**Report: Deficiency Report**  
**Function: Test, Adjust, & Balance**  
**Date: 03/18/2025**  
**Completed By: National TAB**

**PROJECT**  
**03-17-25 CARMAX #7107 ORLANDO, FL**

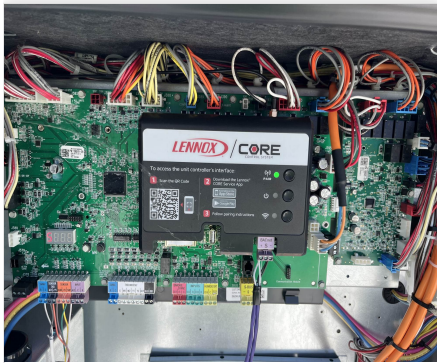
**Issue Name :** RTU 2 Alarm  
**Description :** RTU 2 alarm 17 - High Pressure Strike 3 Compressor 3  
**Created By :** National TAB                      **Assigned To :** National TAB - Will Turnbough  
**Status :** Open  
**Priority :** High                                      **Asset Tag :**  
**Originated Date :** 03/18/2025 - Stephen Tassinaro - National TAB
